## Product Change Notice (PCN)

PCN Number: **PCN-0450915R-01**

Product(s) Affected: *SJ1-2513-SMT-TR & SJ1-2515-SMT-TR*

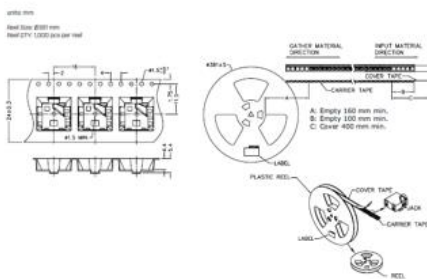
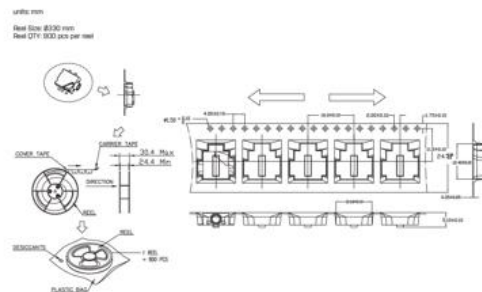
Description of Change: *Minor Housing and footprint differences. Material Change on the housing and terminals. See image Below*
